Addendum #1

Issued June 27, 2024

The following information changes the competitive process documents issued on June 20, 2024.

**Geotechnical Investigation and
Limited Chemical Testing Program
Rosedale Elementary School Addition
25 Erindale Avenue
Hamilton, Ontario**

SITE GRADING & SERVICING PLAN

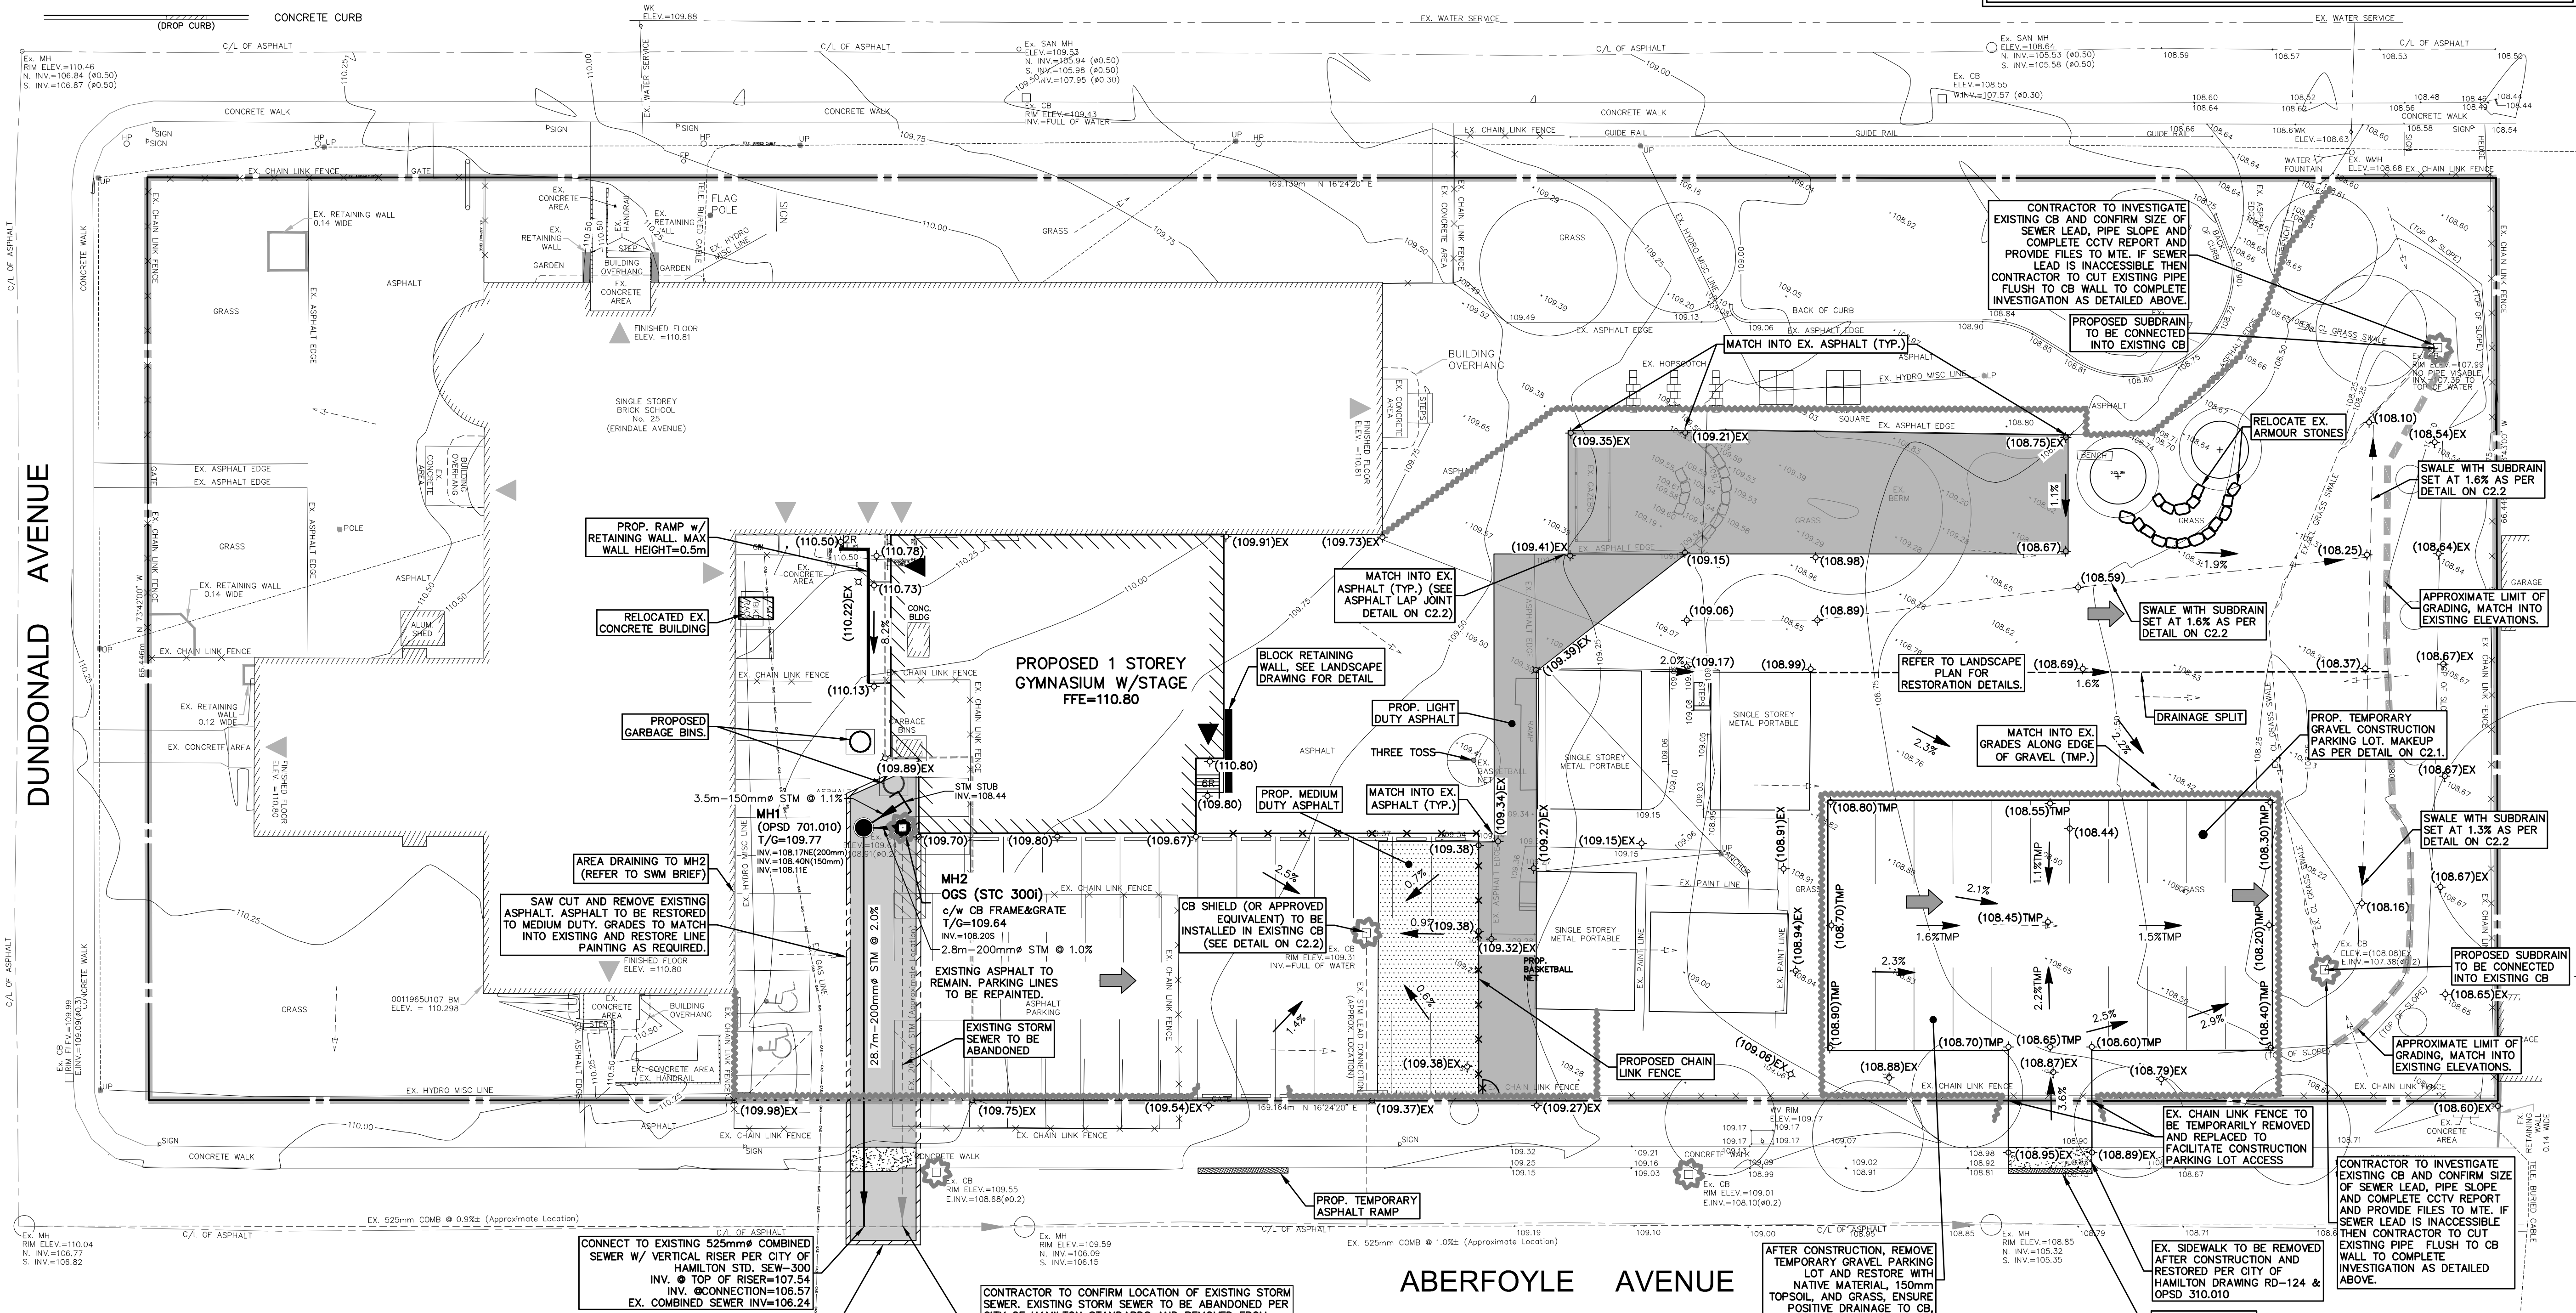
- R4 **We do not have enough information to accept Funktion VSport 710 as an equal at this time.**
- Q5 Please provide grading plan that was properly printed to PDF from AutoCAD. Provided grading plan was scanned from original PDF. Scanned versions of the drawings restricts us to upload them to AutoCAD for grading calculations.

- R5 **Provided grading plan includes all information required to prepare a bid for this project.**
- Q6 A lot of the requirements for lighting are to be coordinated with the BAS. Please clarify who is the existing BAS vendor.
